# 2014 PP INSTALLATION SUPPLEMENT

## » 1190 ADV SKID PLATE - 60303990044

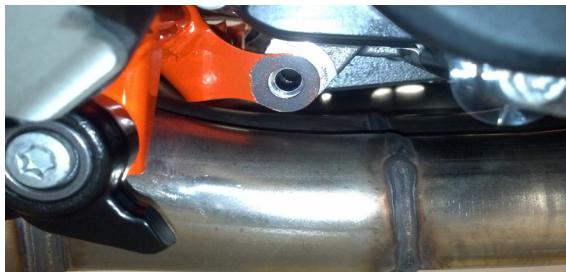
The 2014 1190 ADV PowerParts Skid Plate installation process requires the use of an engine case mounting bolt. In some 2014 1190 ADV models, the hole for inserting the mounting bolt into the engine case is there but not threaded (example below). In this case, the hole will need to be threaded. **\*For 2014 by design for production, this bolt is only required when mounting a PowerParts Skid Plate**

The size of tap needed to add threads to the engine case is a 10mm x 1.5. The recommended drill for this thread tap is 8.5mm and must be used before the tap is inserted to prevent case damage. Only drill into the case 35mm from the outside edge of the frame mount. **\*Reminder - this should only be done if mounting a PowerParts Skid Plate assembly**

Check the original PowerParts Skid Plate mounting instructions to determine the correct size bolt to be used in this location (supplied with the Skid Plate). If the bolt in question is needed, recommended SpareParts bolt is a 10mm x 30mm TORX drive with a 1.5 thread pitch: part number 0035100309. The correct bolt and size for the left side is part number 0035100409. This bolt is 10mm x 40mm with a 1.5 thread pitch TORX drive.
